Re Indian Point Unit No. 3  
Docket No. 50-286

In a March 27, 1975 submittal to your office, we transmitted forty (40) copies of the report entitled, "Preoperational Integrated Leak Rate Test of the Reactor Containment Building; Consolidated Edison Corporation, Indian Point Unit 3", dated March 19, 1975.

Review of the report revealed a typographical error and minor discrepancies in data reduction. The appropriate changes have been made to the report. Enclosed are forty (40) copies of revised pages, together with an instruction sheet outlining the method of incorporating the revised pages into the original report.

Revised Pages for "Preoperational Leak Rate Test of the Reactor Con-  
tainment Building; Consolidated Edison Corporation, Indian Point Unit 3"

21 PSIG POINT-TO-POINT LEAKAGE RATE VERSUS TIME

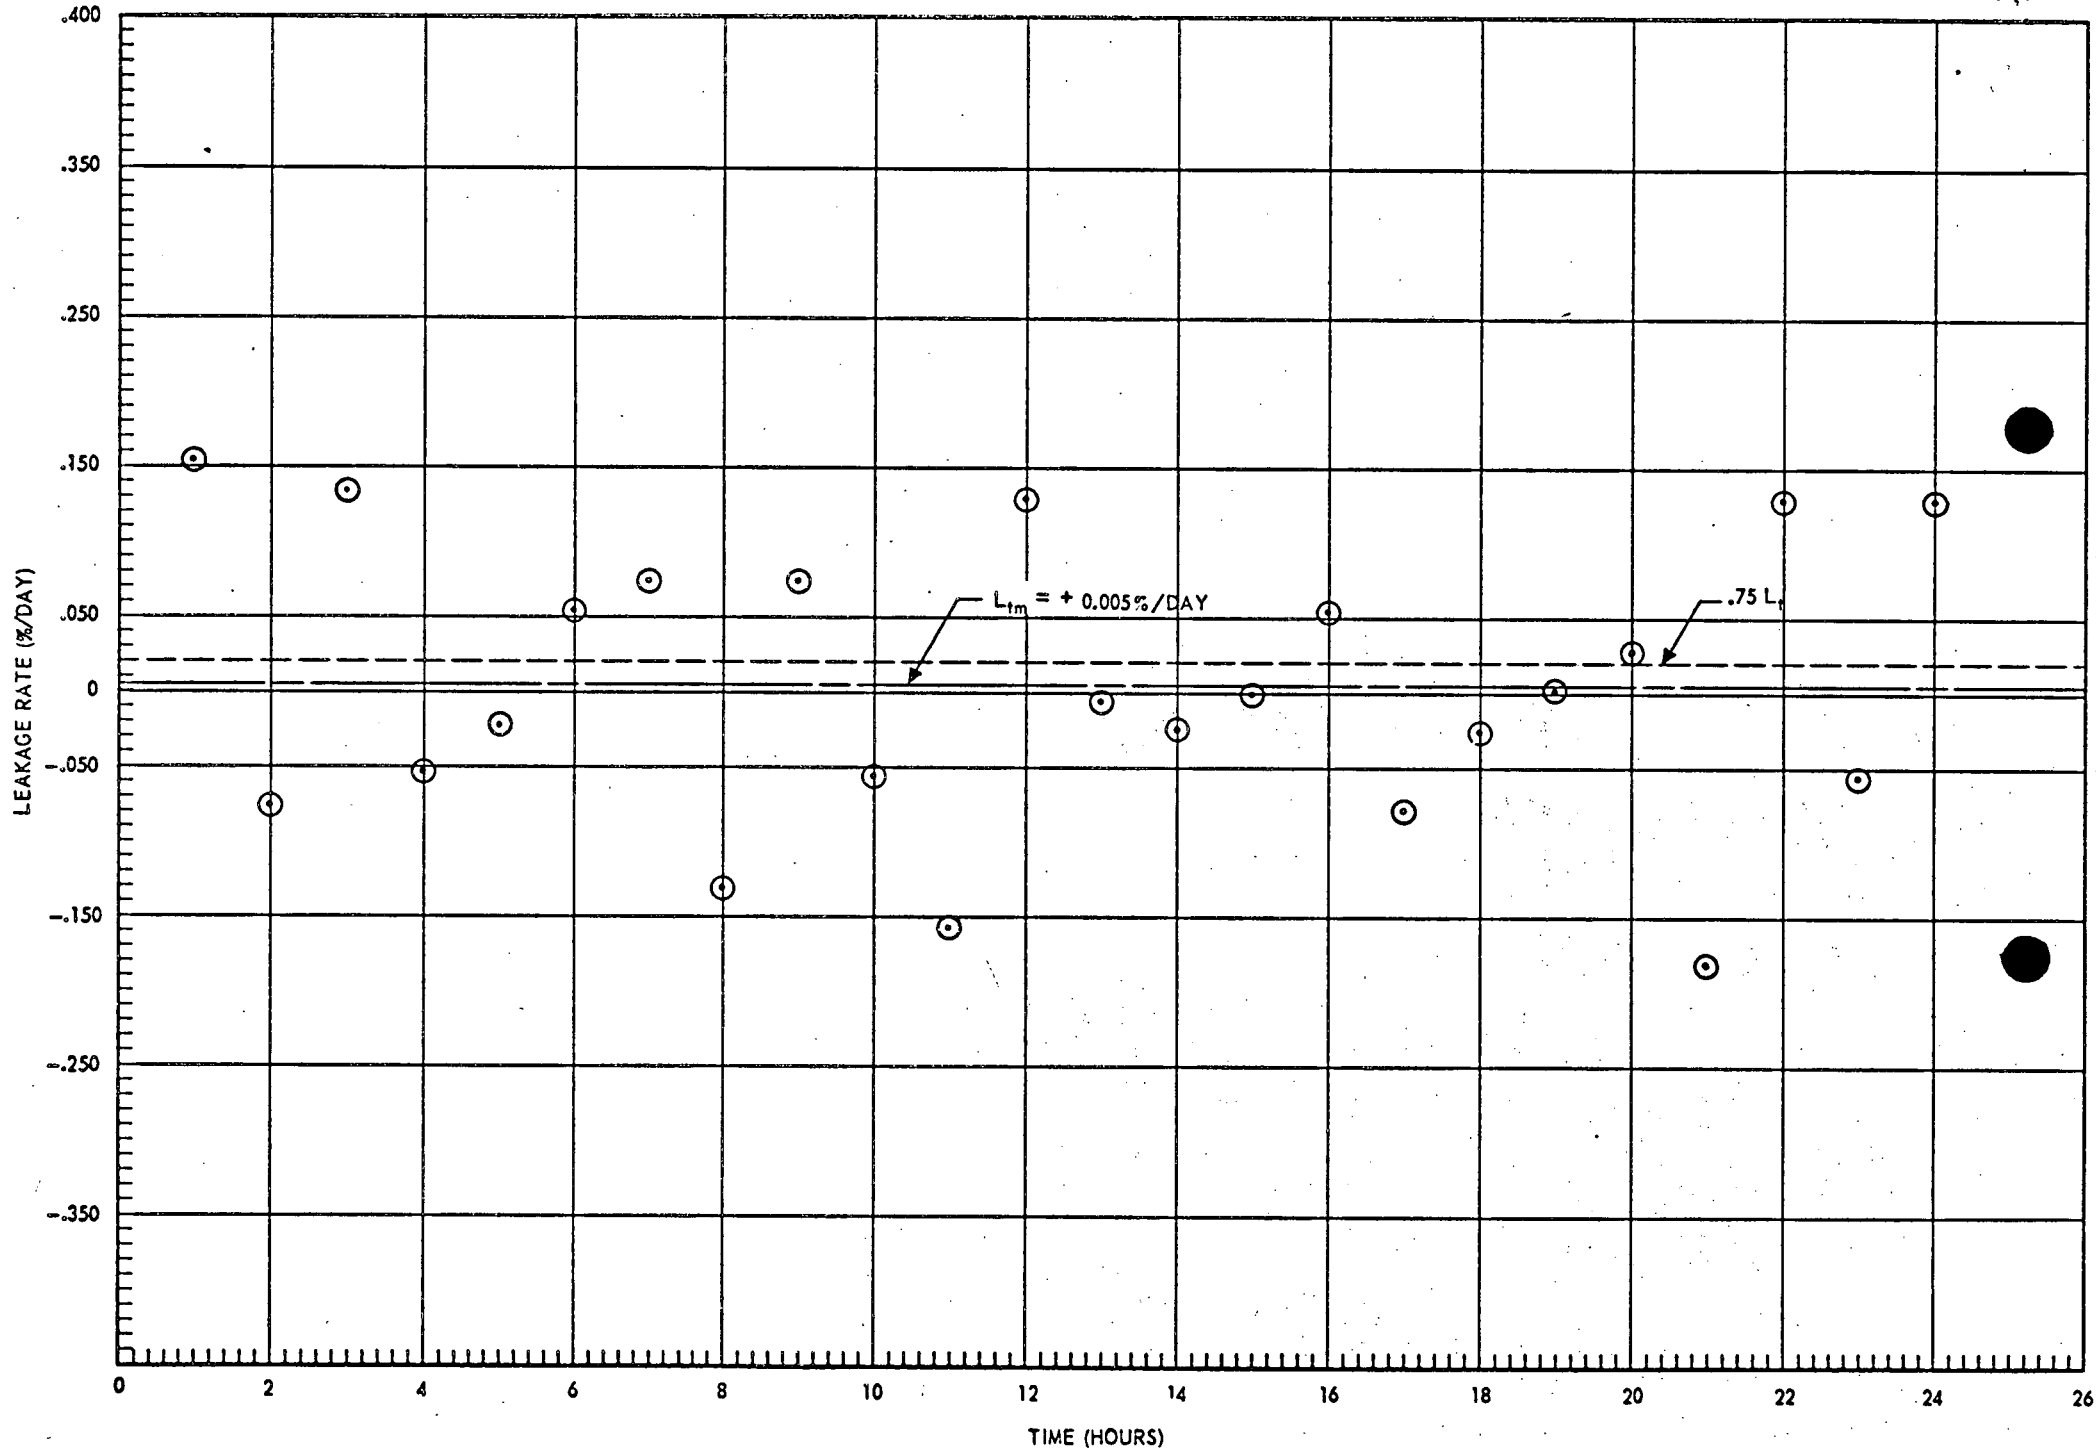
It should be noted that the reported leak rates have changed only slightly. For the test at peak accident pressure, the reported leak rate has changed from 0.023%/day to 0.027%/day. For the reduced pressure test, the reported leak rate has changed from 0.006%/day to 0.005%/day.
